Docket Item # 12  
BAR CASE # 2008-0143

BAR Meeting  
September 17, 2008

**ISSUE:** Alterations  
**APPLICANT:** Bill Montgomery  
**LOCATION:** 430 North Union Street  
**ZONE:** RM/Residential

**Figure 1 Before Photograph**

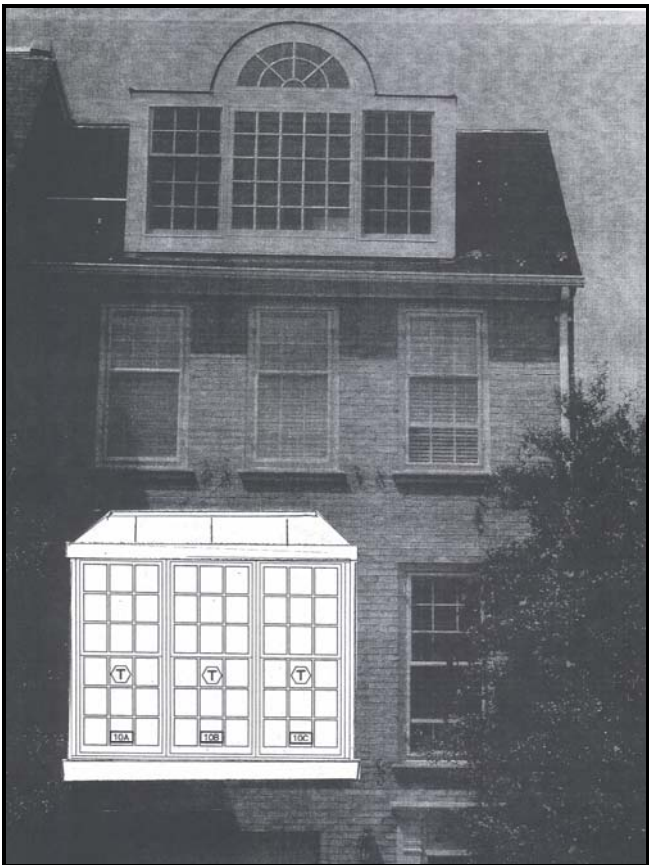
The applicant is requesting approval of a Certificate of Appropriateness for the replacement of two nine-over-nine wood windows with a new bay window on the Union Street façade of the residential rowhouse at 430 North Union Street.

The two windows to be replaced are located on the second floor of the front facade, directly above the garage. The applicant also proposes to remove a portion of masonry from the façade located between the two existing windows proposed to be removed. The proposed bay window to be installed in their place measures approximately 8.5' in width and 6.5' high. It is comprised of three nine-over-nine double hung simulated divided lite, wood, Pella Architect Series windows with unfinished wood exteriors. The three windows making up the bay window are the same size as the windows being removed in addition to a single nine-over-nine window that will remain on the second floor above the front door. The new window will use Pella *Integral Light Technology* in which high-definition 7/8" profile grilles are permanently bonded to insulating glass with a foam spacer bar used between the glass to give the illusion of divided lights. The window will be set into a wooden box that will extend 12" from the façade of the house and be constructed of a plywood base, covered in insulation and then finished with 1x12 wood boards primed and painted to match existing trim on the house. The proposed bay window will have a copper, standing seam, hip roof.
